**JOINT REGIONAL PLANNING PANEL  
(SOUTHERN REGION)  
SUPPLEMENTARY COUNCIL ASSESSMENT REPORT**

<b>Panel Reference</b>	2017STH018
<b>DA Number</b>	RA17/1001
<b>LGA</b>	Shoalhaven City Council
<b>Proposed Development</b>	<p>Demolition and vegetation removal work and staged construction of a Senior Housing development comprising:</p> <ul style="list-style-type: none"> <li>• 89 Bed Residential Care Facility (RCF)</li> <li>• 126 Independent living Units (ILU) (duplex and triplex forms)</li> <li>• 133 ILU spread over 7 x 3 storey residential flat buildings with underground car parking,</li> <li>• Community Centre comprising clubhouse/restaurant/medical centre/gym and swimming pool</li> <li>• ancillary civil infrastructure and landscaping</li> </ul> <p>Roundabout intersection and associated civil works on Princes Highway and surrounding road reserves</p>
<b>Street Address</b>	<p>Lot 1 DP 780801, 276 Princes Highway, Milton  Lot 1 DP 737576, Part Road Reserve Princes Highway, Milton  DP U3 2224 Property ID81992, Part Road Reserve Princes Highway, Milton  DP R63051603 Property ID 81999, &amp; Part Crown Road Reserve Warden Road, Milton – Property ID 81997</p>

<b>consideration</b>	Travers

The vegetation management zones are shown in **Figure 6** of the VMP (D19/354819) Below.

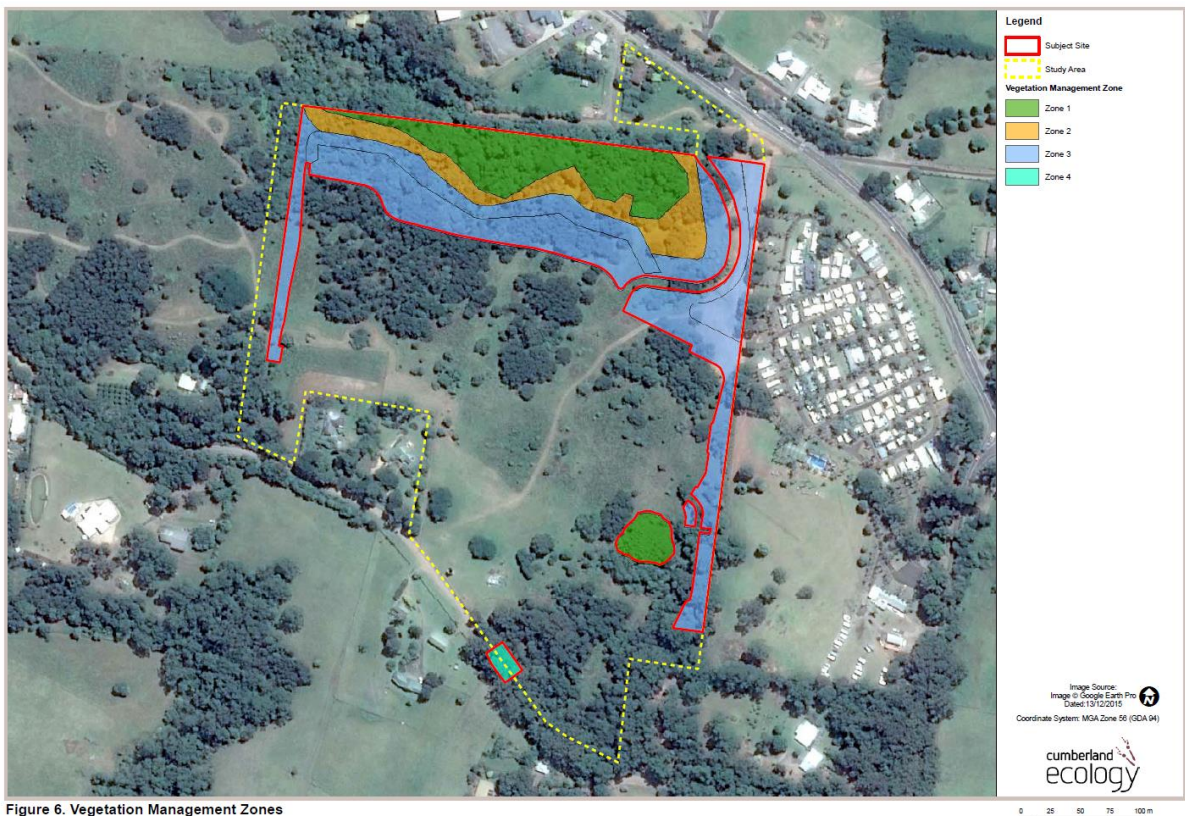
While the Zone 2: Vegetated riparian zone generally achieves or exceeds the minimum 20m buffer distance (green hatched area) there are two pinch points which are less than 20m. It is considered that the intent behind the buffer distance is achieved on average along the length of the Vegetated riparian zone.

Figure 11 – Proposed roundabout works design (D19/355452)

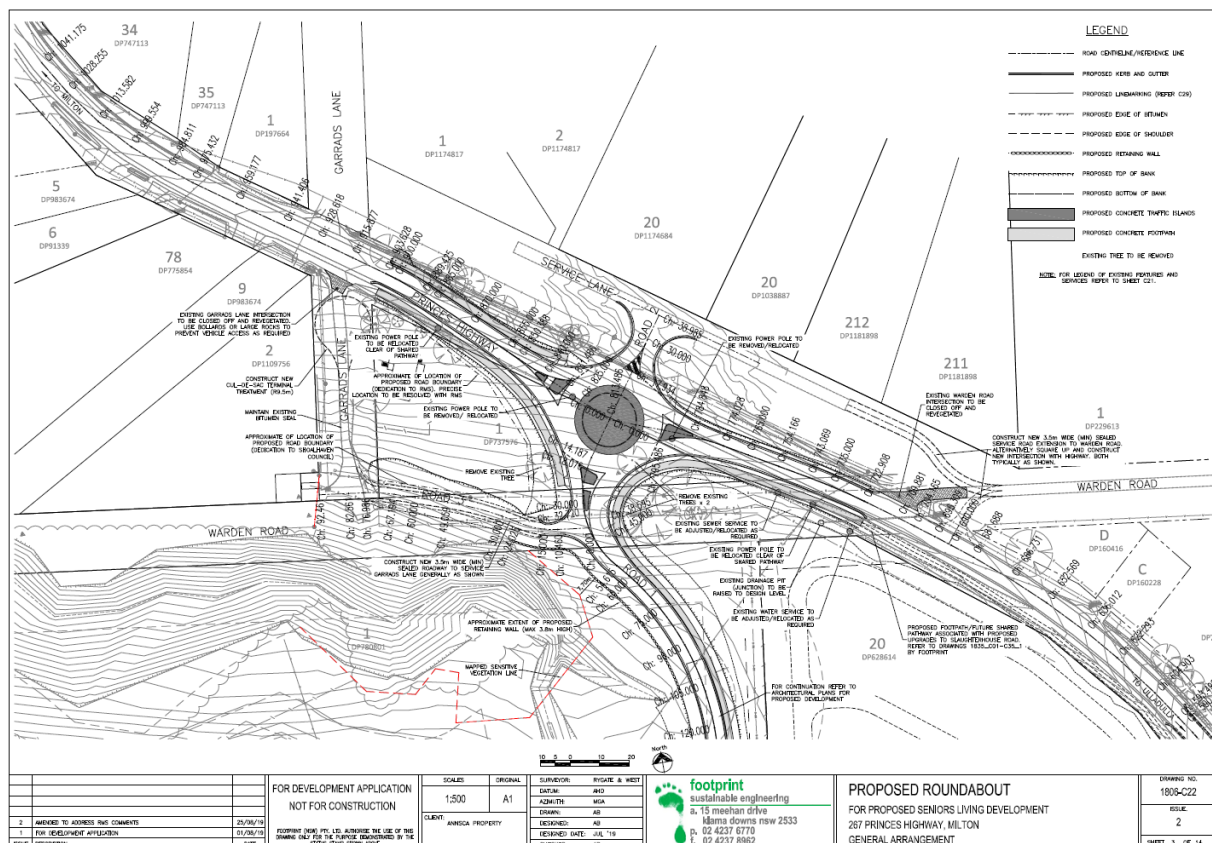
The recommended condition for the noise barrier fence came about as a response to concerns raised by residents on the north side of the highway with the anticipated loss of the vegetated buffer located between the highway and the unnamed service road as a result of proposed road works associated with the roundabout and anticipated increase of noise from vehicles decelerating and accelerating in/out of the proposed roundabout.

The intent behind this recommended condition was to provide some acoustic attenuation of highway traffic noise to affected residents with a secondary benefit of screening glare impacts of vehicle headlights negotiating the roundabout (southbound) and the bend at Warden Road (northbound).

Council acknowledges that it would be reasonable to impose a condition requiring an acoustic assessment to determine the need for an acoustic barrier prior to CC & include design recommendations for height, extent and location of such barrier if required.

Regardless of whether the noise barrier fence is required, Council recommends a revision to the landscape plan be prepared prior to CC to address highway traffic related glare impact to residential premises within vicinity of roundabout and service lane upgrade works and the termination of the existing Warden Road intersection with the highway (north side). Such revised landscape plan would need to be referred

**Figure 12** - Referring to zone 3 (APZ) of the VMP and zone M (Inner APZ - purple) & zone N (outer APZ – dark green) proposed Landscape Plan.

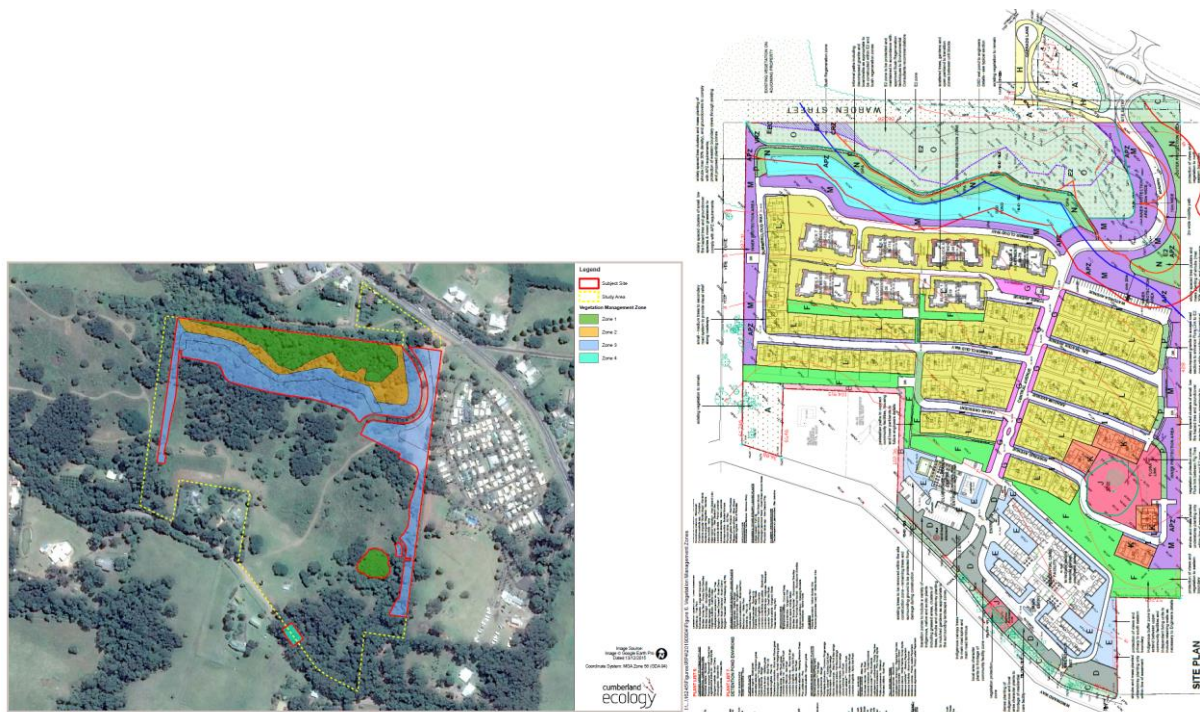
Refer to Clause 7.8 Scenic Protection & Table 10 – Assessment of built form against the 2005 rezoning design principles (SLEP2014 assessment page 51-55 of the Council Assessment Report).
